Safety Recall 24v-193

Claim Preparation & Repair Instructions

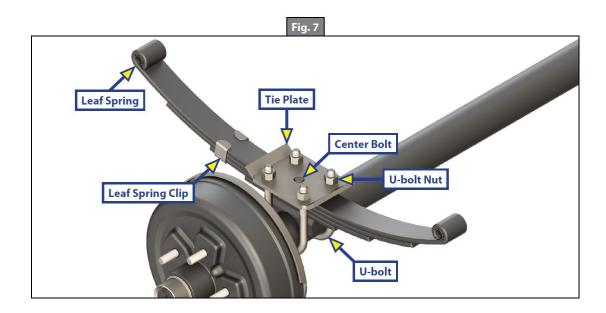
- 1) A. Remove and discard U-bolt nuts (Fig. 6A)
 - **B.** Remove and discard U-bolts (Fig. 6B) and tie (spring) plate (Fig. 6C) from the axle (Fig. 6E) holding the leaf spring (Fig. 6D).

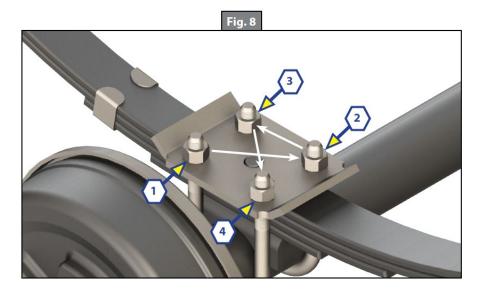
- 2) Position U-bolts and tie (spring) plate on the axle (Fig. 7).
 - A. Hand start and tighten nuts until snug (Fig. 7)
 - **B.** Verify the following:
 - 1. Center bolt is engaged in tie (spring) plate (Fig. 7).
 - **2.** Leaf spring is square to the axle (Fig. 7).
 - **3.** U-bolts are straight up and down and not splayed in or out.
 - **4.** U-bolts have approximately the same amount of thread sticking out of each nut.

3) Progressively tighten tie (spring) plate nuts in a criss-cross pattern, in the order given (Fig. 8), until the final torque is obtained. Proper torque for a 6k to 8k axle is 90 ft-lbs (this torque value must be specified on your preauthorization).
